04 - 2010
9924DB
3 X 24" BELT SANDER

SERVICE CHANGE

3. Change on Gear Cover Complete

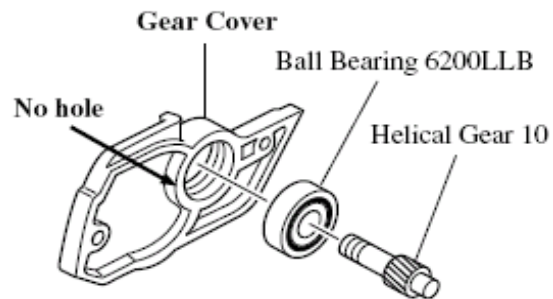
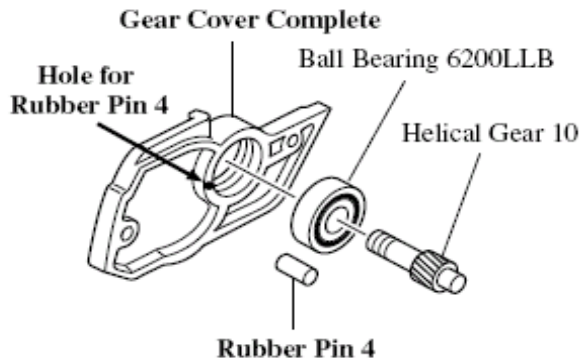
Item No.	Description	Type 1	Type 2
49	Gear Cover Com	152206-7	312808-3
55	Rubber Pin 4	263002-9	-----

Rubber Pin 4 (a constituent part of Gear Cover Complete) has been eliminated. Consequently, new Gear Cover has no hole for Rubber Pin 4.

Note: Rubber Pin 4 is necessary for the current Gear Cover Complete (Pt. No. 152206-7). When using the current Gear Cover Complete, do not remove the Rubber Pin 4 from it.
